Technical Service Bulletin (TSB)
Service Hybrid Electric Vehicle System Warning Message

REFERENCE:	TSB: 08-116-25 REV. B GROUP: 08 - Electrical	Date:	September 3, 2025	REVISION:	08-116-25 REV. A
VEHICLES AFFECTED:	2023 - 2025 (JL) Jeep Wrangler This bulletin applies to vehicles built on and before October 14, 2024 (MDH 1014XX) equipped with 2.0L I4 DOHC DI Turbo Engine W/ESS (Sales Code ECX).			MARKET APPLICABILITY: ☒ NA ☐ SA ☒ **EE ☒ MEA ☒ IAP ☒ CH** NOTE: **This bulletin applies to North America, Enlarged Europe, India & Asia Pacific, Middle East & Africa and China markets.**	
CUSTOMER SYMPTOM:	Customers must experience a Malfunction Indicator Lamp (MIL) illumination and the vehicle must exhibit/set the following Diagnostic Trouble Code (DTC): - B273C-00 - Digital Crash Input. NOTE: Technicians may find the DTC is stored or pending in the Hybrid Control Processor (HCP). Customers may experience one or more of the following: - The "Service Hybrid Electric Vehicle System Warning" message and Light are displayed in the Instrument Panel Cluster (IPC) Fig. 1. NOTE: This message may be displayed for a few seconds and then disappear. - The vehicle may no longer enter Electric or Hybrid

Fig. 3
Ferrite Bead Assembly

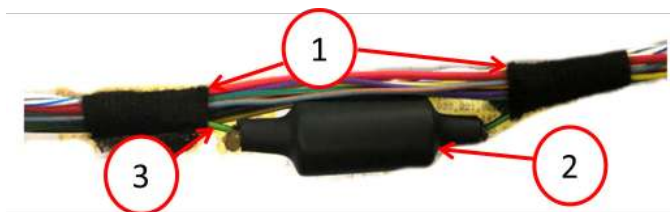
10. Place circuit R414A through the ferrite bead and install the ferrite bead **between clips 1107 and 1108**, [Fig. 2](#) and [Fig. 3](#).
11. Install two butyl patches around wire circuit R414A at both openings of the ferrite bead [Fig. 3](#).

12. Place heat shrink tube over circuit R414A and ferrite bead [Fig. 3](#).
13. Using a heat gun, heat the heat shrink tubing around ferrite bead, ensuring sealant flows out of each end tubing [Fig. 3](#).
